CLARIFICATIONS # 1

Contract name.: Supply, Installation, Maintenance of relevant equipment and services for the introduction of consumption-based heat metering and thermostatic heating valves in District Heating, Prishtina		
Reference No.: BD / QPBS / 2021/003		
Date: 22.04.2021		
No.	Question	Answer

Schema Metering and Billing Software.p

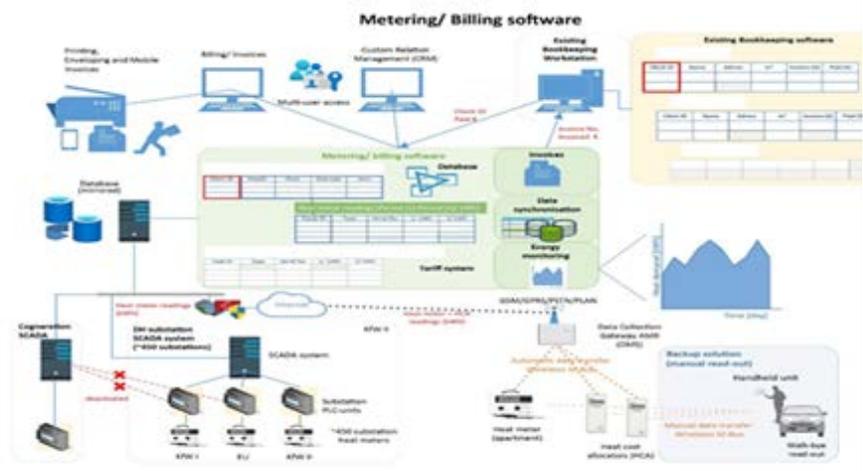
Do the bidders have to provide system architecture based on their proposed system or not?

Please clarify?

Yes. Bidders have to provide system architecture (hardware + software) to fulfill the functional requirements stated in chapter 7.1 and 7.2 in Part 2 - Supply Requirements.

SR 4 - Drawings

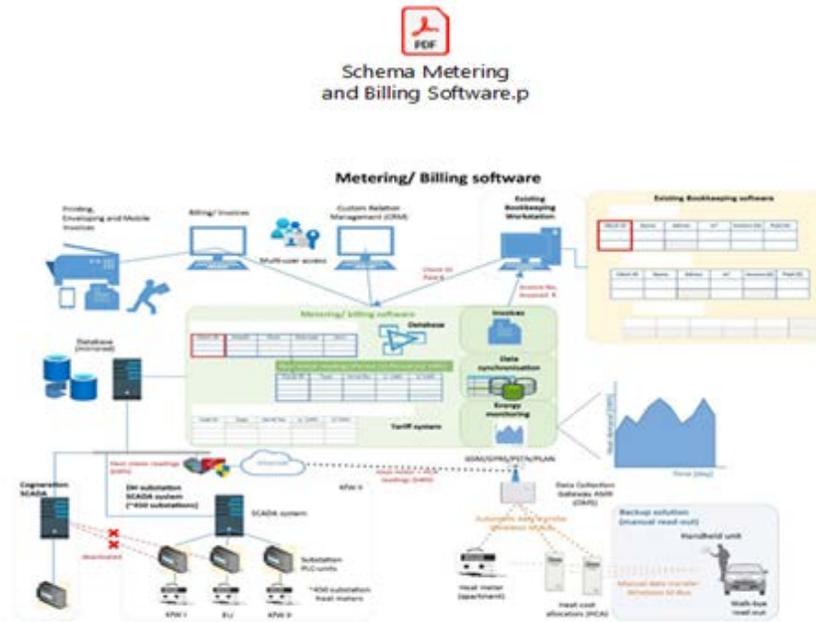
- Do the bidders have to provide system architecture based on their proposed system or not?
- In the tender documents it is mentioned that new provided system needs to be integrated with existing Bookkeeping Workstation.
- At which level and methods these integration needs to be?

Yes. Bidders have to provide system architecture (hardware + software) to fulfill the functional requirements stated in chapter 7.1 and 7.2 in Part 2 - Supply Requirements.
